RE: Fiesta Subaru
7100 Lomas Blvd NE
30-day Temporary C.O. - Accepted
Engineer's Certification Date: 07/06/23
Engineer's Stamp Date: 01/12/22
Hydrology File: K19D108A

Re: Grading and Drainage Certification (Fiesta Subaru, 7100 Lomas Blvd. NE)
Hydrology File K19D108A

**WAIVER APPLICATION FROM STORMWATER
QUALITY VOLUME MANAGEMENT ON-SITE**

PROPOSED
DRAINAGE
MANAGEMENT
PLAN

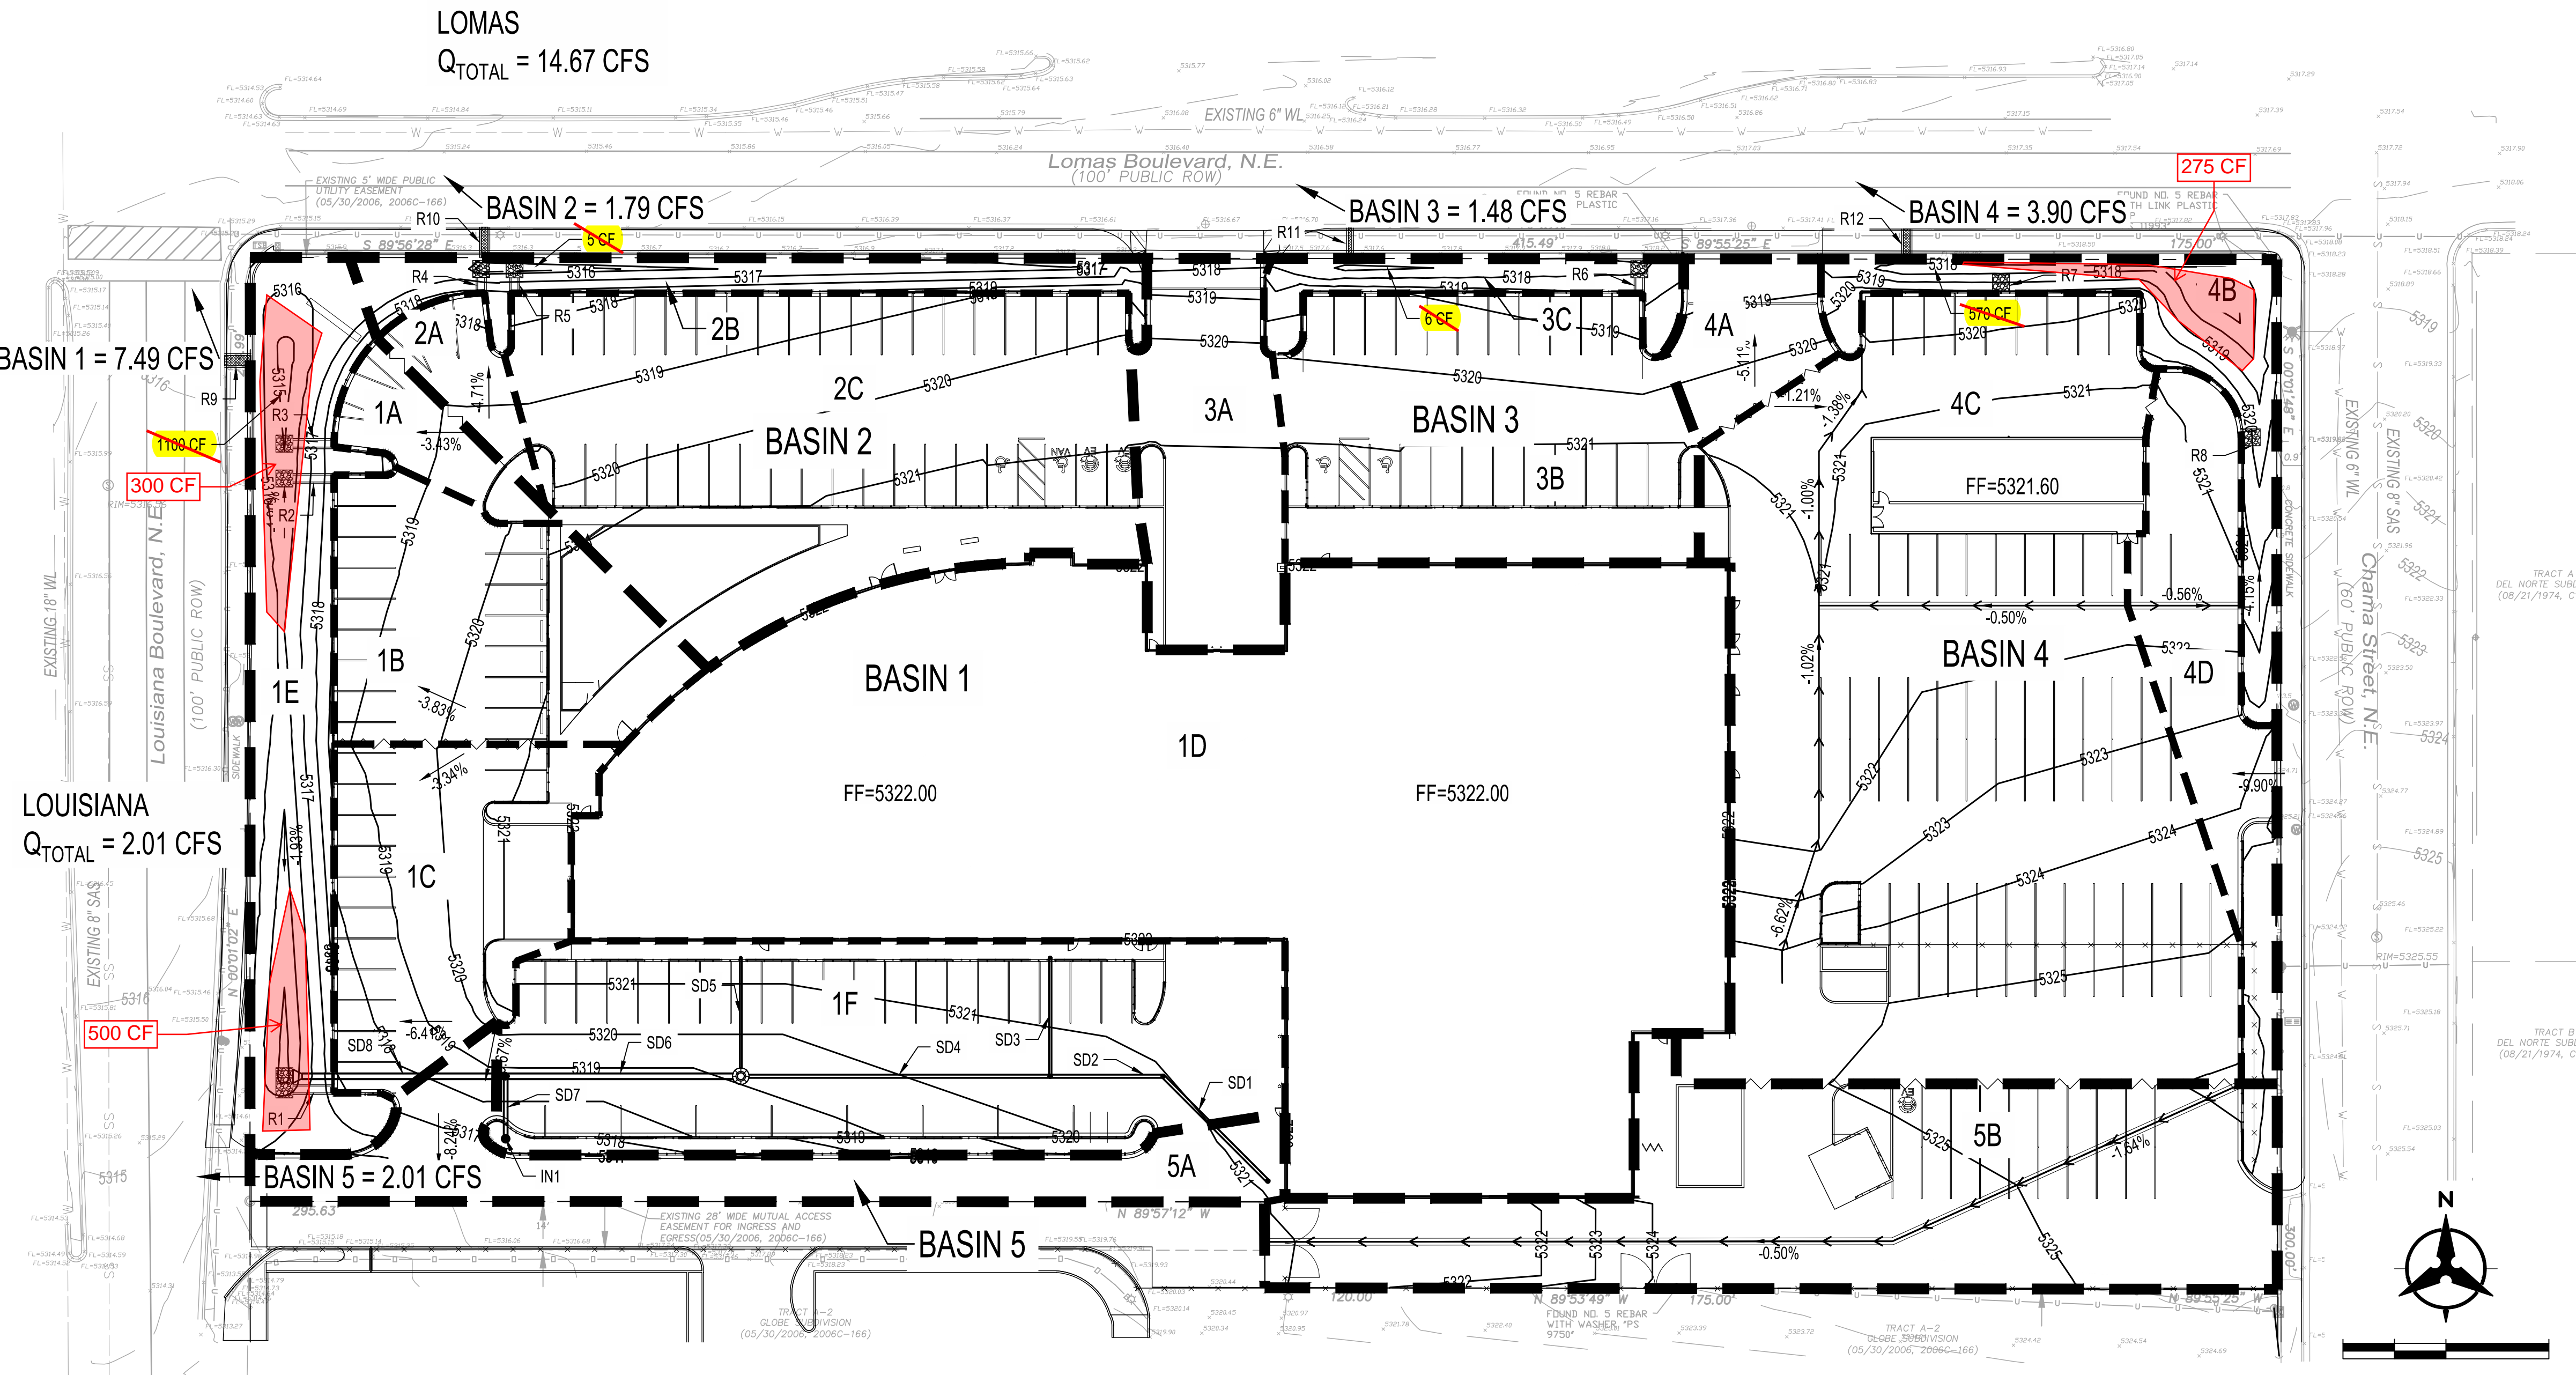
STORMWATER QUALITY VOLUME REQUIRED = 3,280 CF
STORMWATER QUALITY VOLUME PROVIDED = 1,075 CF
STORMWATER QUALITY VOLUME REMAINING = 2,185 CF

ALL LANDSCAPED AREAS ARE DEPRESSED TO THE MAXIMUM EXTENT FEASIBLE. ADDITIONAL VOLUME CANT BE ACCOMMODATED DUE TO THE SITE CONSTRAINTS.

Based on as-built elevations of ponds and revised volume listed above, Payment in Lieu is
2,185 CF * \$8/CF = \$17,480
Previous SWQ Waiver approved 2/25/22 and Fee in Lieu of \$12,744 already paid.
Remaining fee in lieu to be paid is
\$17,480 - \$12,744 = \$4,736

GRADING
PLAN

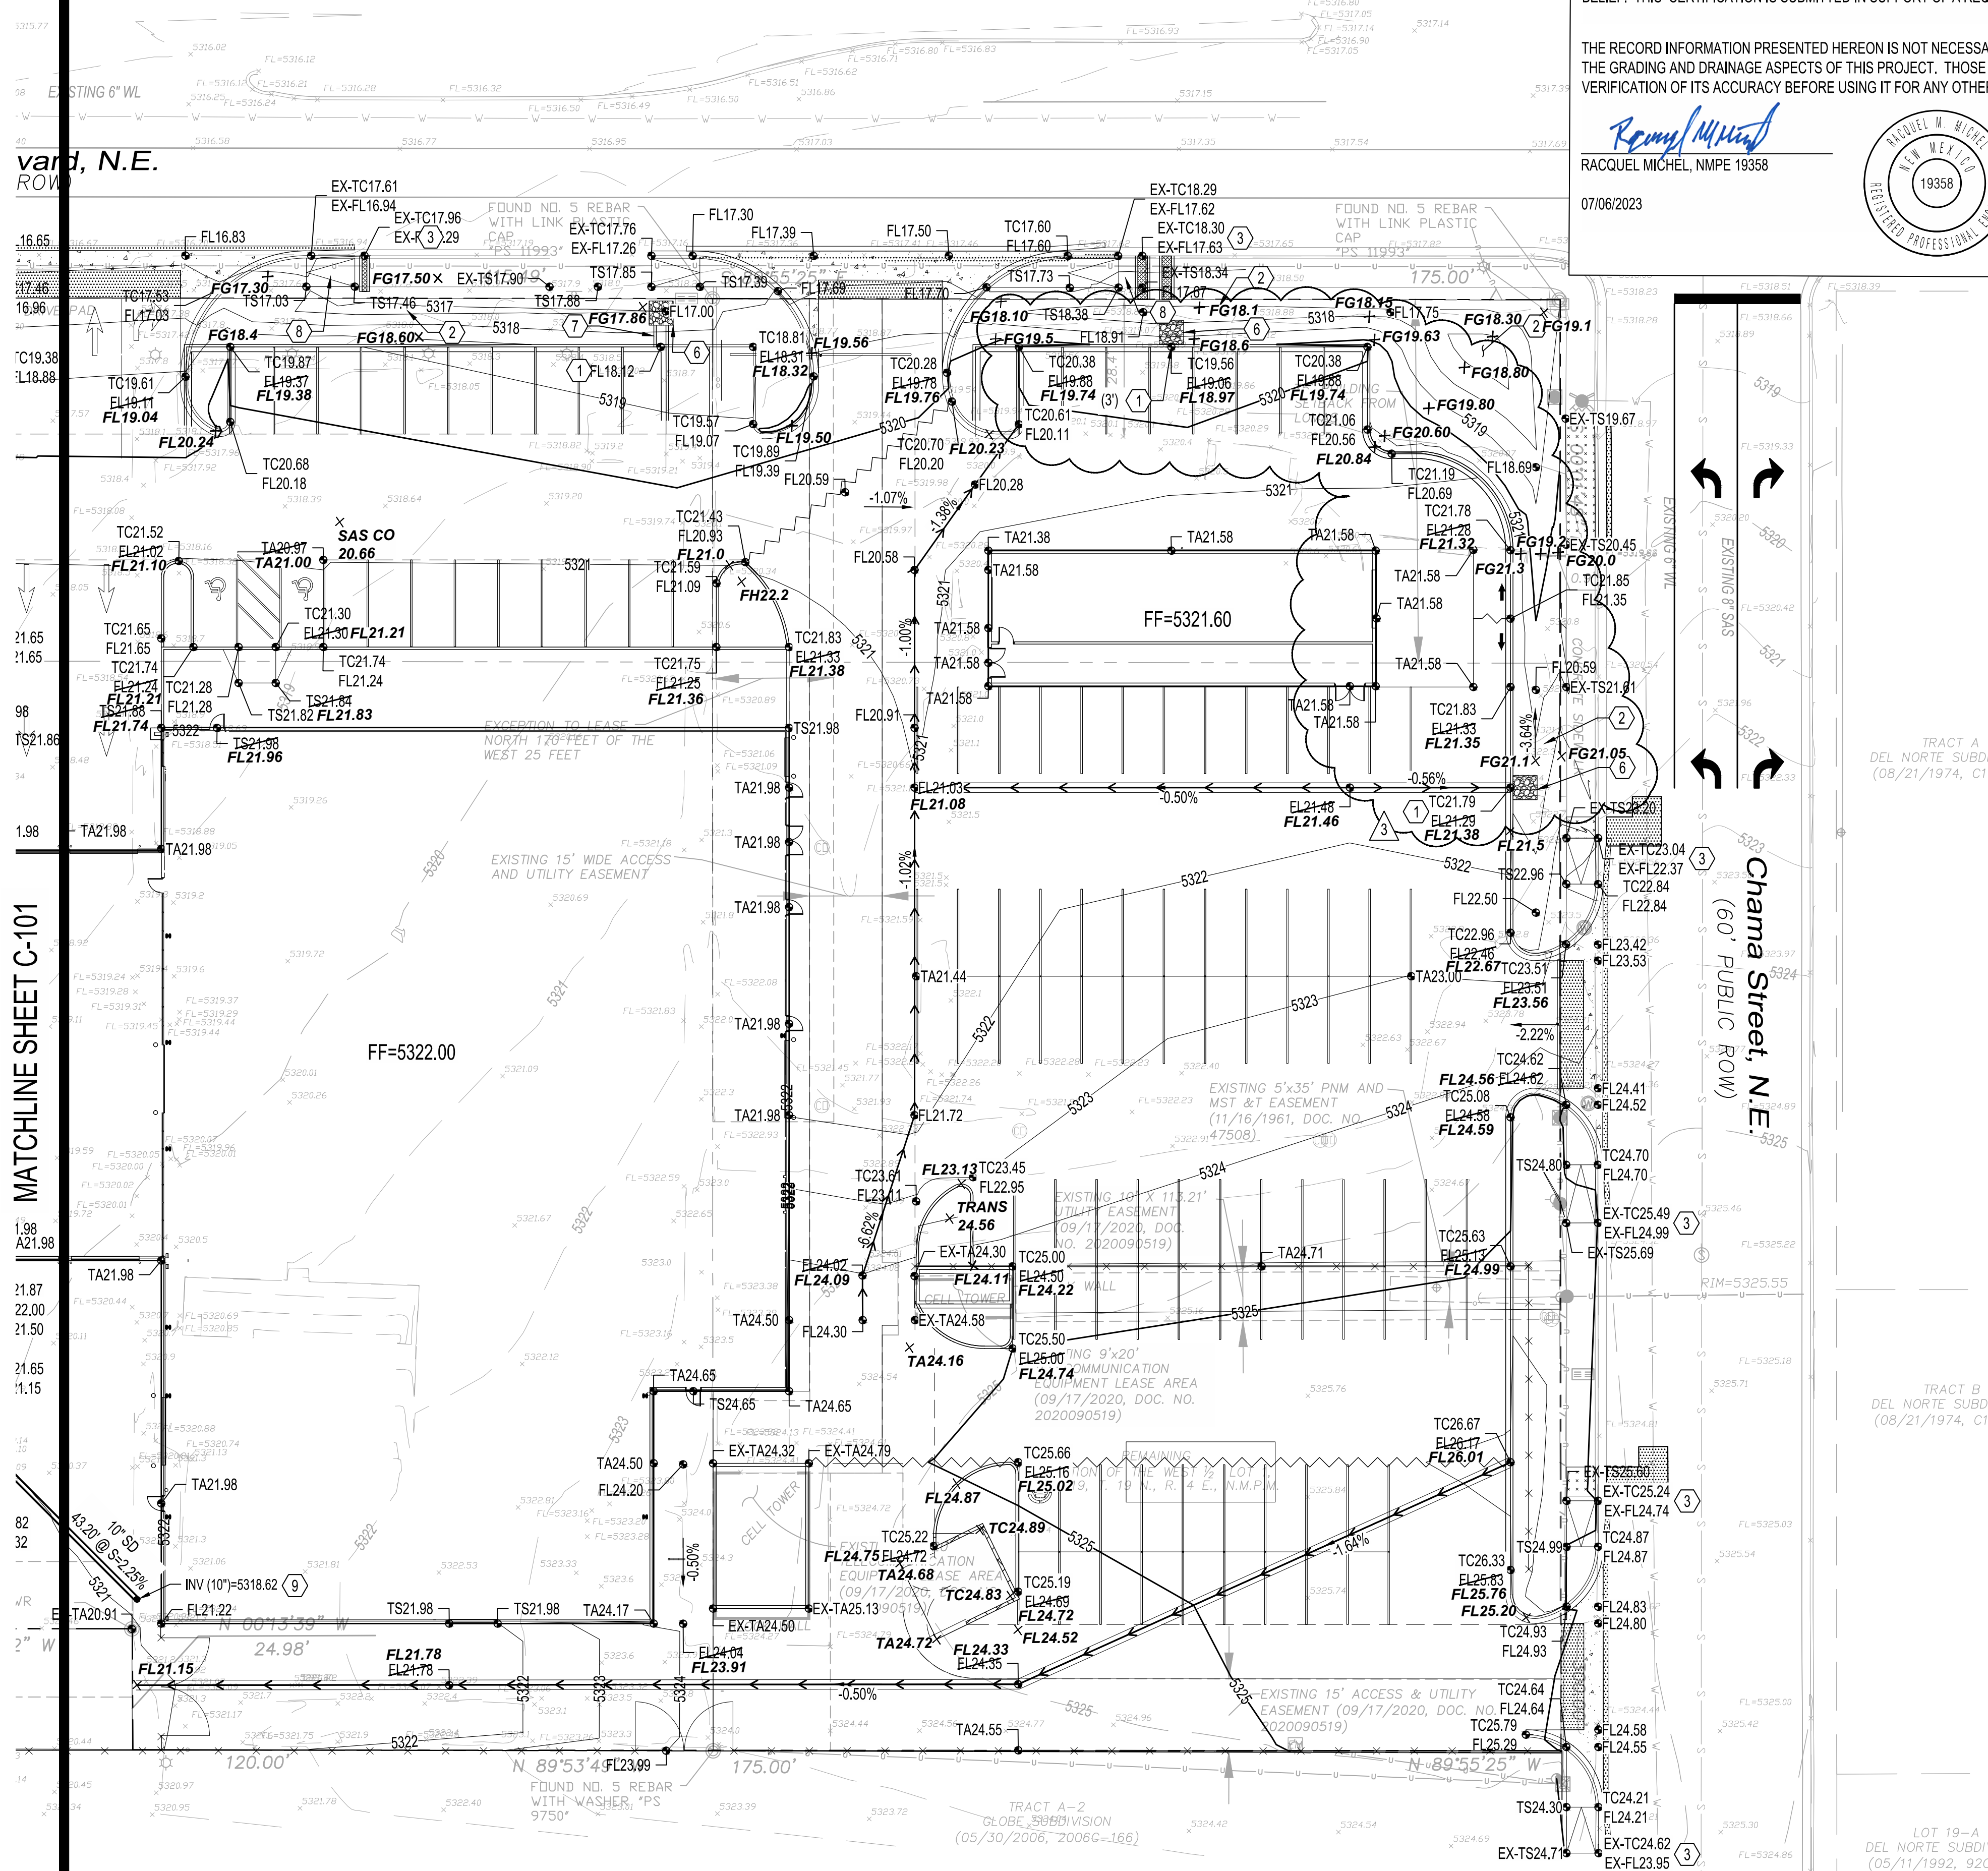
The site work has been constructed and based on our review there are a few items to be corrected that have already been communicated to the contractor through a punchlist report and will be corrected in the field. These items are noted on the as-built survey for your reference and documentation. With your review, we are requesting that only the Temporary Certificate of Occupancy (TCO) be released and that once all the punchlist items are completed and the cash in lieu is submitted, that the Permanent CO be released.
